Access Compliance Report

Public Rights-of-Way

Intersection ID: 49241	Main Street: HUBBARD_POINT_DR	Cross Street: TOXAWAY_LN	Location: SE
ADA ID: 926987BC9A52	Ramp Type: PerpDiag	Initial Pass/Fail: Fail	Overall Compliance: No
Codes/Mitigation Info/Possible Solution		Field Measurements/Component Compliance	
Severity Score: 13.75

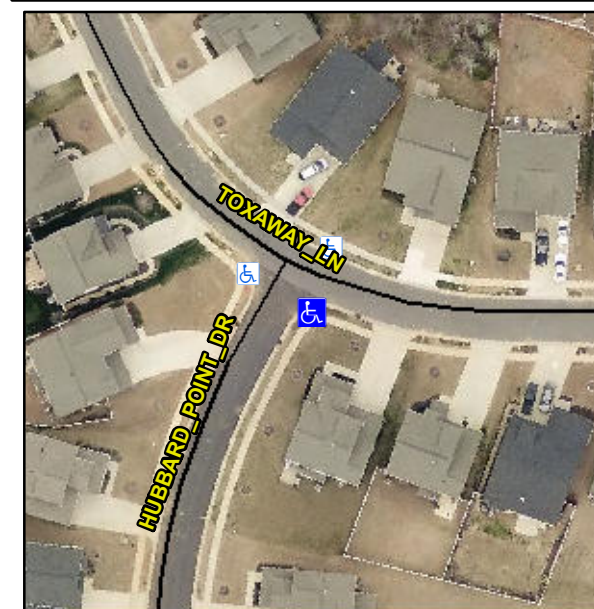
Not Found, R304.2.2, R304.5.3

Compliance	Description	Data	Compliance	Description	Data
N/A	Ramp Length (in)	48.0	No	Ramp Slope (%)	9.6
Yes	Ramp Width (in)	48.0	No	Ramp XSlope (%)	3.1
N/A	Flare Type LT	N/A	N/A	Flare Type RT	N/A
N/A	Flare Slope LT (%)	N/A	N/A	Flare Slope RT (%)	N/A
N/A	Flare Traversable LT?	N/A	N/A	Flare Traversable RT?	N/A
N/A	Landing Length (in)	N/A	N/A	DWS Provided?	N/A
N/A	Landing Width (in)	N/A	N/A	DWS Contrast?	N/A
N/A	Landing Slope (%)	N/A	N/A	DWS Length (in)	N/A
N/A	Landing X Slope (%)	N/A	N/A	DWS Full Width?	N/A
N/A	Landing Curb? (Y/N)	N/A	N/A	DWS Offset (in)	N/A
N/A	Shared Landing?	N/A			
N/A	Gutter Ponding?	N/A	N/A	Gutter Slope (%)	N/A
N/A	Gutter Lip Ht (in)	N/A	N/A	Gutter X Slope (%)	N/A
N/A	Painted X Walk1?	No	N/A	Painted X Walk2?	No
	X Walk 1 Direction	To NE		X Walk 2 Direction	To NW
N/A	X Walk 1 Width (in)	N/A	N/A	X Walk 2 Width (in)	N/A
	X Walk 1 Slope (%)	0.2		X Walk 2 Slope (%)	0.6
	X Walk 1 X Slope (%)	0.3		X Walk 2 X Slope (%)	2.0

Remove & Replace Curb Ramp With Two New Directional Ramps or Equivalent.
